LUMINARY Memo #83

To: Distribution
From: J. Kernan
Date: 19 May 1969
Subject: LUMINARY Revision 98

Setting of Word Order Bit in LUMINARY 98.

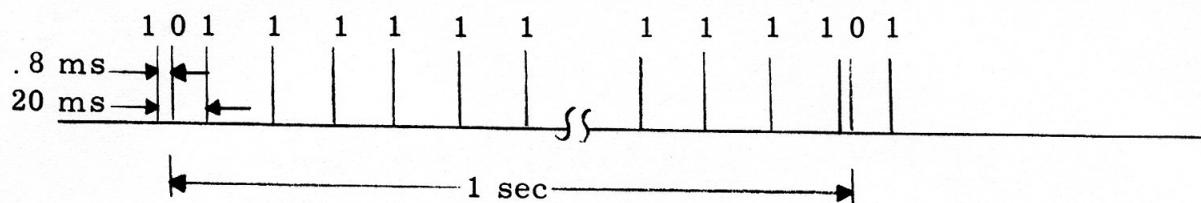
- 1) The coding to initialize the LAMBERT iteration counter (ITERCTR) was restored to INITVEL. See LUMINARY Anomaly 65. The counter is initialized to 20 D for coasting flight (Lambert targeting) or 5 for powered flight. This change affected Rope Module 2 (bank 11₈).
- 2) The Down-Telemetry program was changed to decrease the frequency at which it writes into output channel 13 bit 7 (the word order bit). In SUNDANCE and all previous revisions of LUMINARY, the write rate of the word order bit is 51 per second, fifty 1's and one 0. This change reduces the rate to twice per second, one 1 and one 0. The two writes are nominally separated by 19.2 milliseconds.

This change affected rope module 1 (Bank 5).
